## Lessons Learned - for Utilities and NDE inspectors

## Review of 1997 inspection of U-bend tubes at Indian Point2

Figure 1 400 kHz C-scan of tube 2-69 of steam generator 24 made in 1997

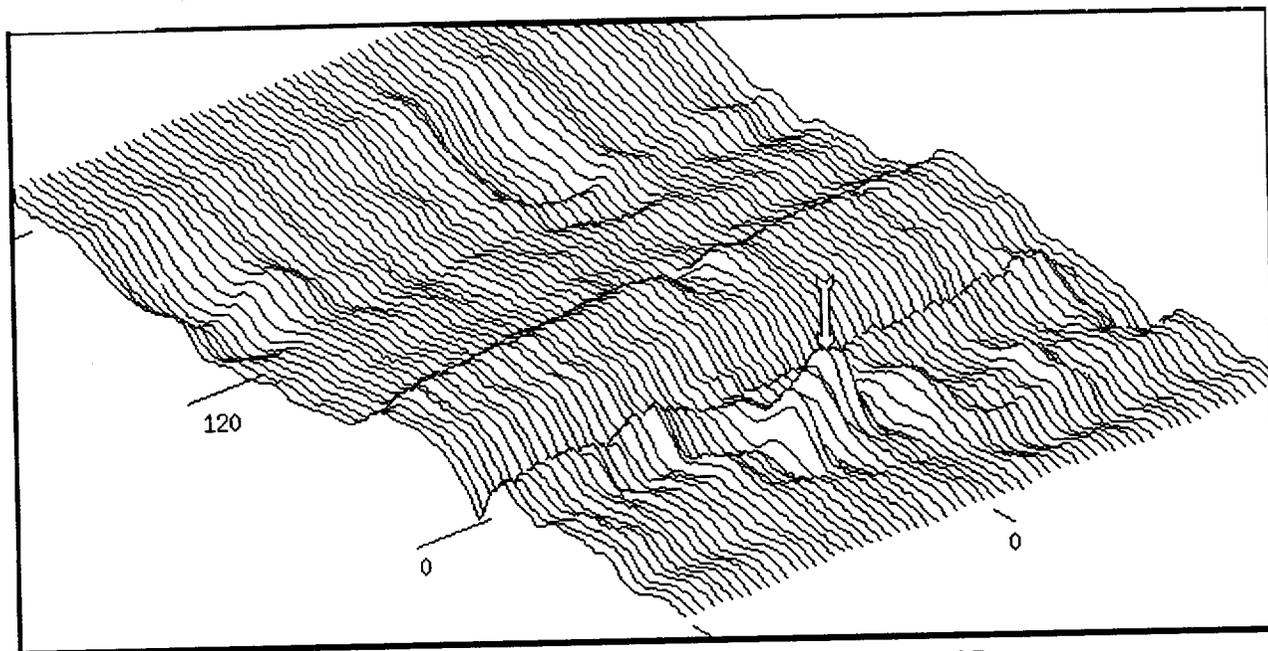
The 400 kHz C-scan of tube 2-69 of steam generator 24, made in 1997, is shown in Figure 1. While the amplitude of this signal is small (1.2-volts), it does stand up above the noise, enough at

least for the analyst to look at the Lissajous of the signal.

Figure 2 400 kHz C-scan of tube 2-87 of steam generator 21 made in 1997

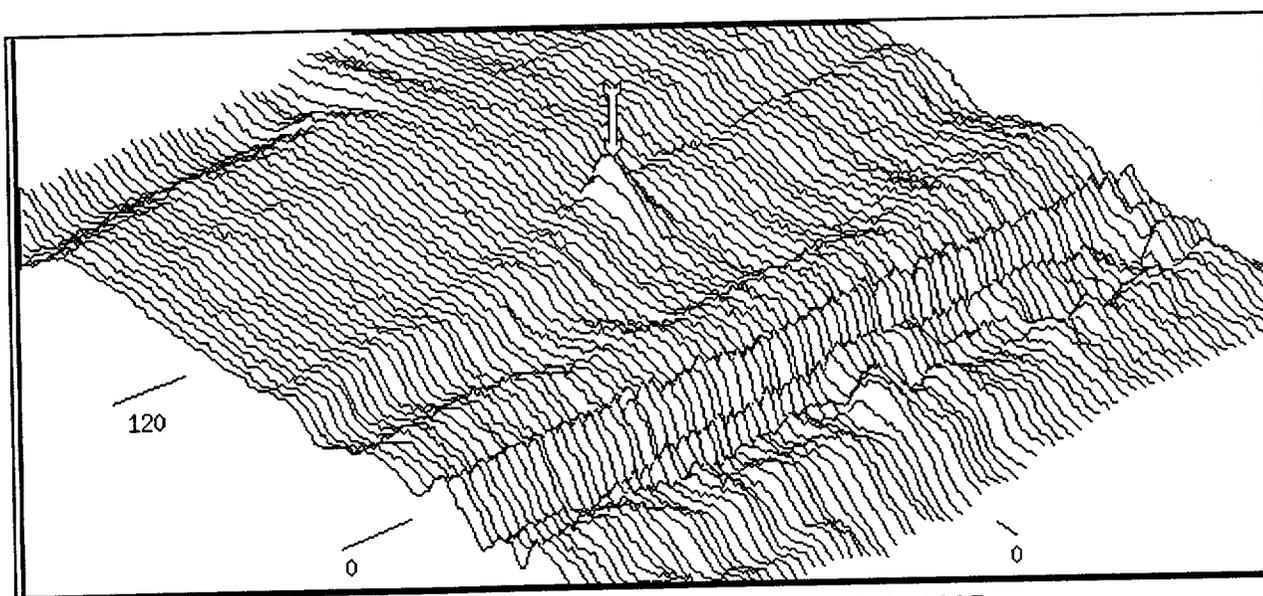
The C-scan of tube 2-87 of steam generator 21 is shown in Figure 2. This tube has a defect

signals of about 1-volt in a relatively clear part of the tube. This signal looks very much like the one found in tube 2-67 during the 1997 outage. A careful examination of the C-scan of this tube will show enough of a signal for the analyst to look at the Lissajous signal. This tube also has several long cracks at about the same axial location as the defect that is in the clean section. They are partially obscured by a noise ridge.

Figure 3 400 kHz C-scan of tube 2-5 of steam generator 24 made in 1997

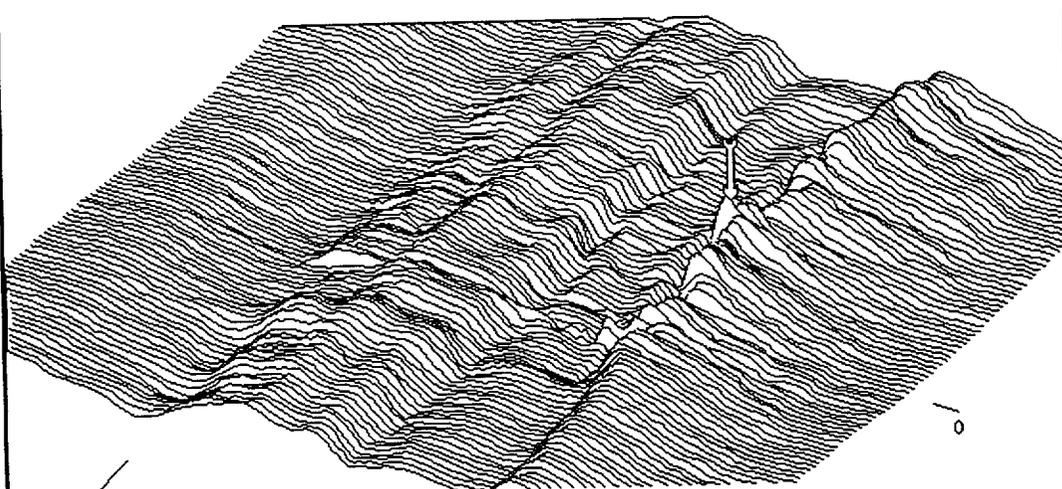
The C-scan of tube 2-5 of steam generator 24, made at 400 kHz in 1997 is shown in Figure 3.

The defect is shown riding on top of the deposit ridge. This defect becomes much more apparent if a circumferential average filter is used. The use of this filter on tube 2-5 is shown in Figure 4. This type of filter computes the average value of the vertical component of the signal over all of the axial extent of the scan, for each point around the circumference of the tube.

Figure 4 400 kHz C-scan of tube 2-5 of steam generator 24 using a circumferential average filter.

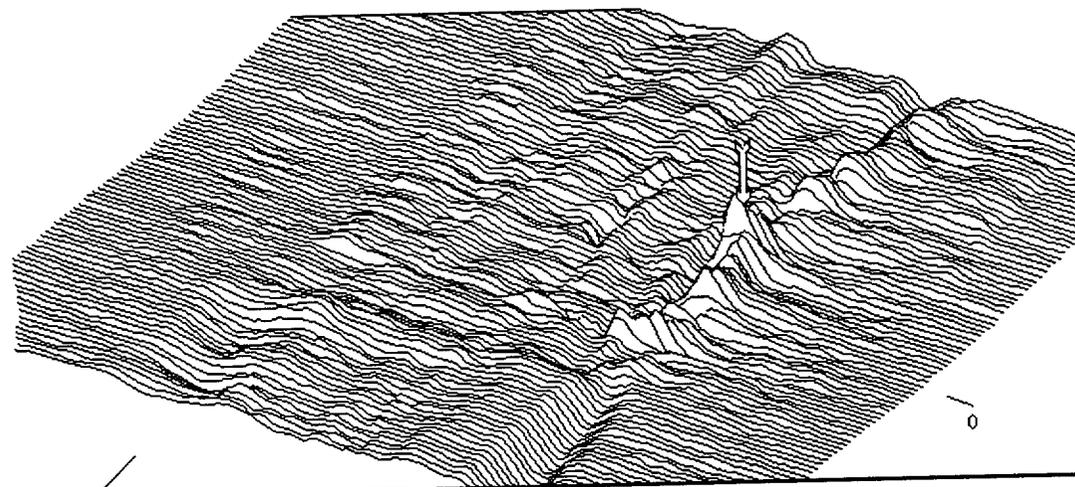
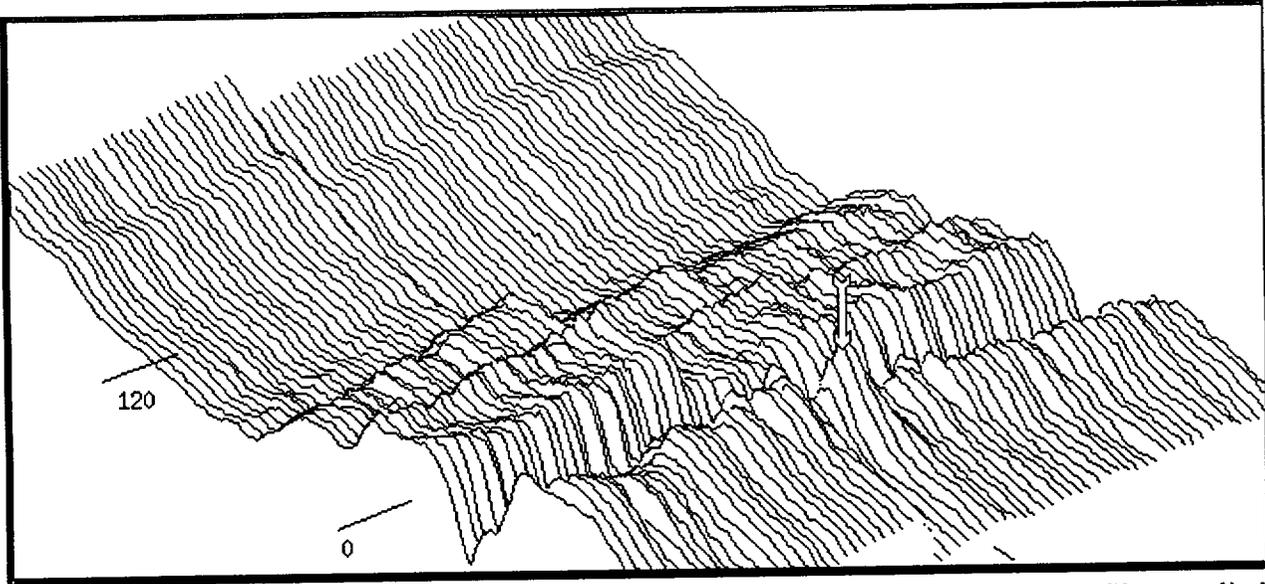
This average value is then subtracted from the scan, and the scan of the difference is re-plotted. This is particularly effective in removing the long ridges of noise from the scans. The differences in the axial direction are then emphasized. The 1997 guidelines state that "Mixing and filters are not required but are optional." In general, Westinghouse does not encourage the use of filters.

**Figure 5** 400 kHz C-scan of tube 2-72 of steam generator 24 made in 1997, with no filter applied helped here also. This tube is shown in Figure 5.

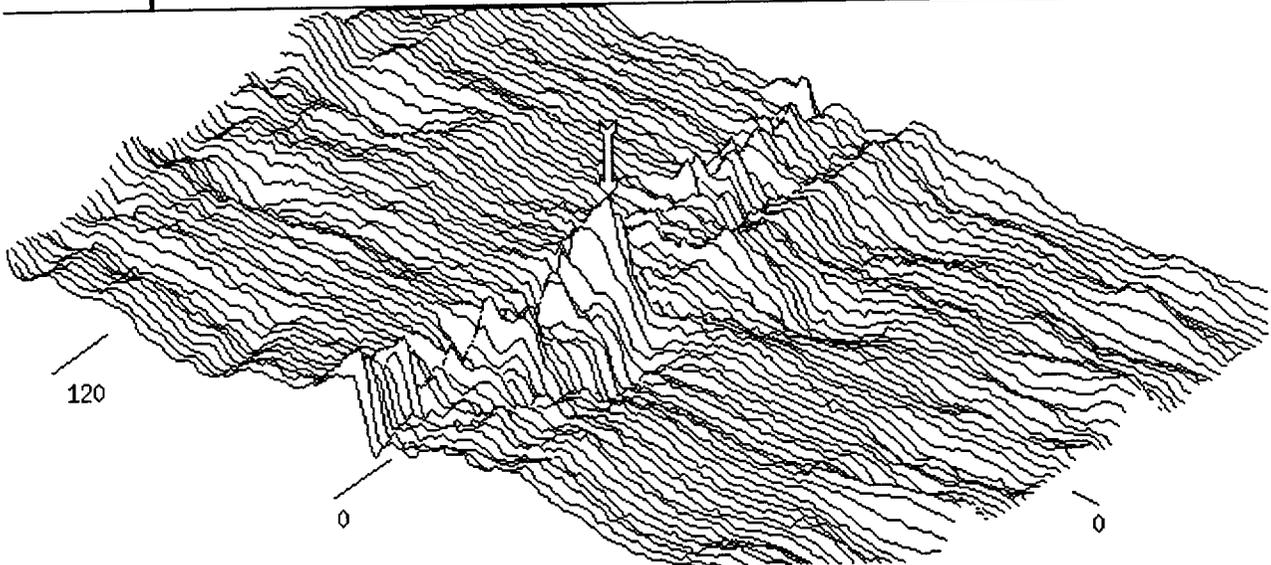
Tube 2-72 of Steam generator 24 is similar to tube 2-5, and could possibly be detected from the C-scan, without the need of any filter, although a circumferential average filter would have

**Figure 7** Tube 2-85 of SG23 in 1997 at 400 kHz, with circumferential average filter applied.

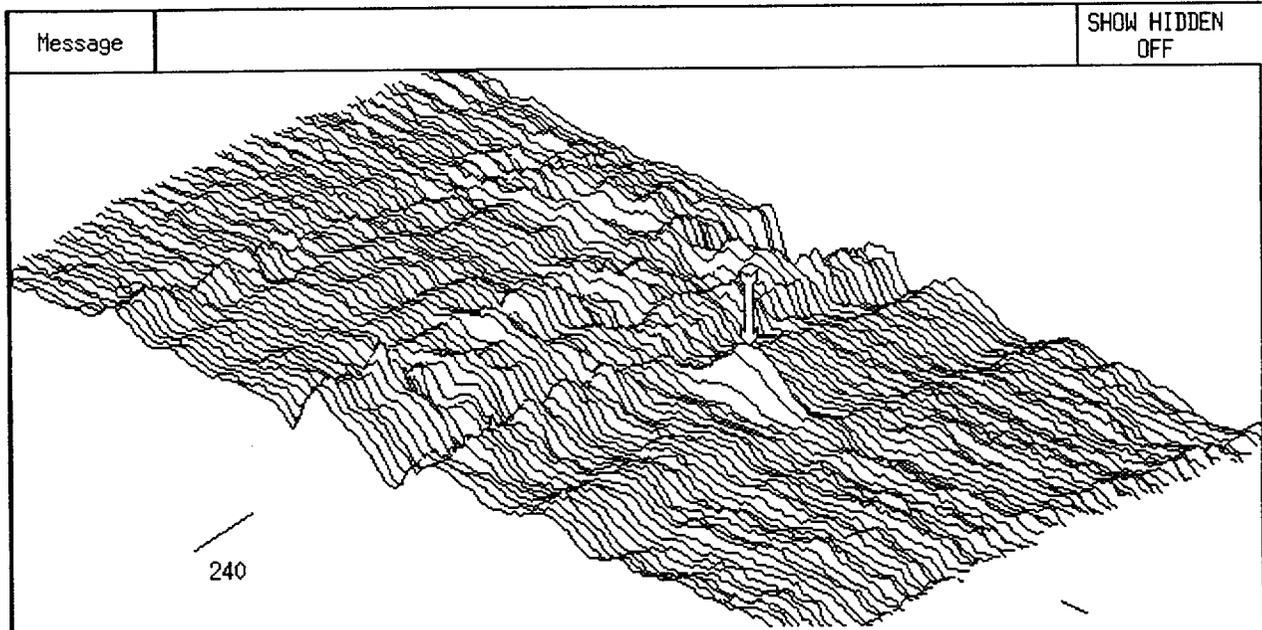
Tube 2-85 of steam generator 23 also needs the circumferential filter for detection, as shown in Figure 7.
